Access Compliance Report

Public Rights-of-Way

(Curb Ramps)

Intersection ID: 12433	Main Street: HARGROVE_AV	Cross Street: MIDLAND_AV	Location: NE
ADA ID: 5DFB0CBF4A18	Ramp Type: ParaDiag	Initial Pass/Fail: Pass	Overall Compliance: No
		Severity Score: 0

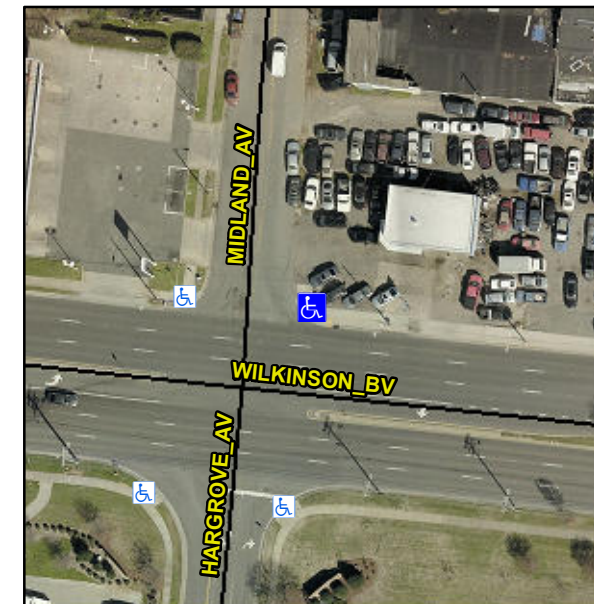
LT RP < 5%

Not Found, R304.2.1, R305.2

Remove & Replace Curb Ramp With Two New Directional Ramps or Equivalent.
